City of Sweet Home

Staff Report Presented to the Planning Commission

FILE NUMBER: SD21-01

Foothills Ridge Subdivision will create 26 lots for single-family dwellings on 6.50 acres located on Linn County Assessor's Map No. 13S01E32CA, Tax Lot 4403 (Attachment B). Lots created by the proposed subdivision will provide a variety of sizes. The smallest proposed lot is 8,226 square feet, while the largest lot is 9,950 square feet. The proposed subdivision's average lot size is 8,932 square feet.

FOOTHILLS RIDGE SUBDIVISION

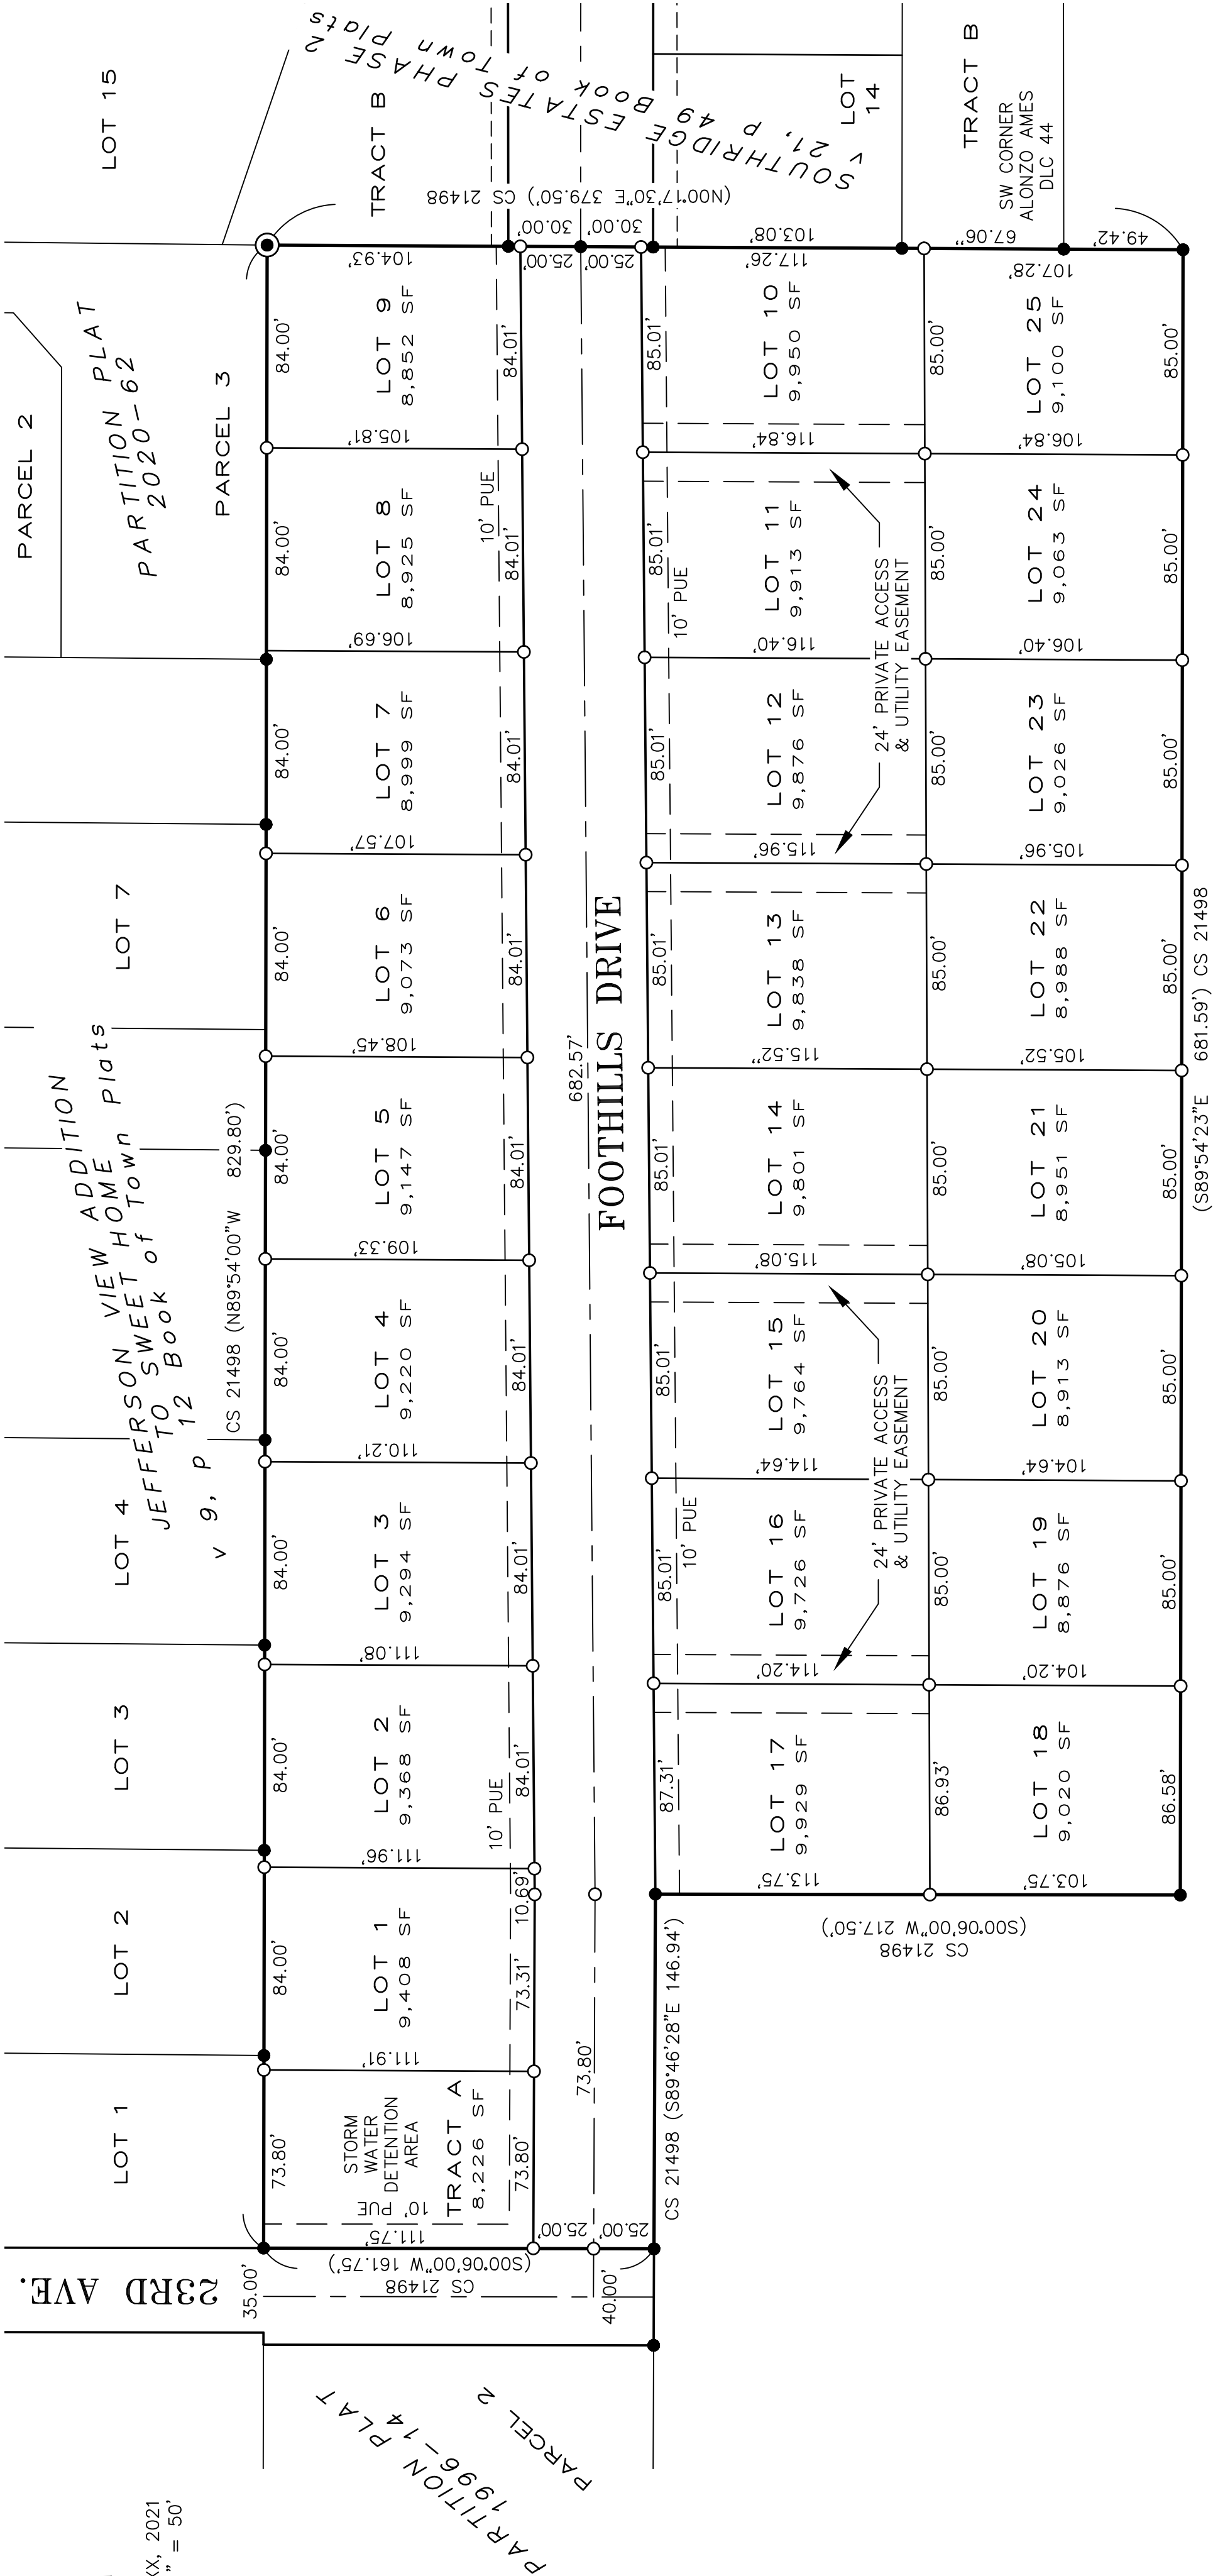
The TSP roadway dimensions require a minimum 3-foot planter strip for Local Streets which the narrative and plan do not show. Foothills Drive is wide enough for planter strips to be constructed and are required. The proposal shows a 50-foot right-of-way, which provides adequate width for 5 feet sidewalk, 4 feet planter, and 30-foot curb to curb widths which provides the minimum 7 feet parking and travel lanes, etc. However, 23rd Avenue is only 40 feet wide with some portions at 35-foot-wide, the planter strips are not required, and sidewalks can be curbside.

The City of Sweet Home wants to have provision for a waterline easement in the common driveway are serving Lots 24 and 25 on Lots 10 and 11. The easement would be the same size as the proposed shared utility and access easements as noted on the Plan Option B. The easement would run from the south right-of-way line of Foothills Drive to the south line of Lots 24 and 25. The City is looking forward 15-20 years to a need for an additional water reservoir in the area, with the adjacent property to the south at the right elevation and location. It has access from Ames Creek road, so that only a waterline would be connected through the lots. We would likely place a conduit in the ground at the time of construction to feed the future waterline through, without the need for excavation at that future time.

This development will need to link the proposed water system on Foothills Drive to Harding Street. 23rd Avenue had a very small waterline that was inadequate to connect to. However, city water crews have recently removed that work item from the subdivision requirements with our replacement in April 2021 of that waterline. The city has placed 250 foot of 6" waterline in 23rd Avenue from the Harding Street 6" waterline southward to a few feet from the drainage channel culvert. The city has done this work for our own distribution system needs; the developer would have had to do this otherwise. This proposed subdivision shall connect at the new end point now, with a crossing under the channel. The channel culvert currently has only 6"-8" of cover.

The Fire & Ambulance District is requiring that the NE corner of Foothills Drive and 23rd Ave be a rounded corner with a 20-foot radius, to facilitate turning of large vehicles. The properties on the south boundary accessed by easement do not indicate if the front residences will or will not connect to that shared driveway. If they do then each driveway will have four residences, lessening the number of driveway aprons to Foothills Drive itself. However, it may create some issues with emergency services and access to those residences.

Because of the limited width of 23rd Ave, and the potential awkward connection to the adjacent drainage channel if it was done in the roadway, the outlet from the detention basin is shown to connect to that channel on the property of Lot 1 (Anderson) of Jefferson View Addition. An easement will be necessary on that property if there is not one currently available.

The tentative plan does not show how the development will accommodate runoff from the south hillside. There will need to be an easement, channel, area catch basins or some combination of those along the south line of the properties. That stormwater collection will then be another pipeline in the shared driveway easement down the driveway to Foothills Drive. The southern properties are about 12 foot to 15 foot above the central flat portion of the development.

The plan indicates a curb and sidewalk along the east side of 23rd Avenue. That would be a "half street" which is really a "3/4 street" on the ground, comprised of sidewalk, curb and drainage, pavement to the centerline and the opposite lane. There will need to be curb on that side too because residents will travel to and from the subdivision in both directions on 23rd Ave. Because of the very poor condition of 23rd Avenue, and it being the most direct path westward to the community, the improvements on 23rd Avenue need to extend to Harding Street. The City may be able to partner with the developer to improve the street network at 23rd Ave and Harding Street. The city is currently looking to overlay both streets, so by the time this proposed subdivision starts construction, there may already be good pavement in portions of 23rd Ave and Harding Street.

The indicated proposed mainline sewer systems appears to be able to provide each lot with service. For the properties on the south boundary that appear to be sharing the driveway accesses, each lot will have its own sewer lateral line.

2. The applicant shall provide a waterline easement through Lots 10, 11, 24 and 25 in the common driveway that serves Lots 24 and 25. The easement would be the same size as the proposed shared utility and access easements as noted on the attached site plan (Attachment B). The easement would run from the south right-of-way line of Foothills Drive to the south line of Lots 24 and 25.

3. The applicant shall link the proposed water system on Foothills Drive to Harding Street. The proposed subdivision shall connect to the new 6 inch waterline end point, with a crossing under the channel. The channel culvert currently has only 6"-8" of cover.

4. The applicant shall install a street name sign at the intersection of Foothills Drive and 23rd Avenue.
5. The stormwater basin shall remain under private ownership and not be transferred to the City of Sweet Home. The maintenance of private stormwater basins is up to the local residences with or without a HOA.

6. The applicant shall provide an easement on adjacent Lot 1 (751 23rd Avenue) to provide a connection to the storm water detention area.
7. The applicant shall provide stormwater collection easement along Lots 18-25 to accommodate the run-off from the south hillside. The storm water collection will be through the utility easements to Foothills Drive.

8. On 23rd Avenue, the applicant shall develop "half street" improvements," on the ground, comprised of sidewalk, curb and drainage, pavement to the centerline and the opposite lane. The improvements on 23rd Avenue need to extend to Harding Street.

9. The applicant shall provide each lot with its own sewer lateral line.
10. Within one year from date of the approval of the tentative plan, the applicant shall prepare a final plat in conformance with the approved tentative plan, the provisions of this title and the provisions of O. R. S. Chapter 92. The applicant shall submit a final subdivision plat for approval by the City according to the procedures and requirements of SHMC 16.20. The applicant shall provide all information required by SHMC 16.20.
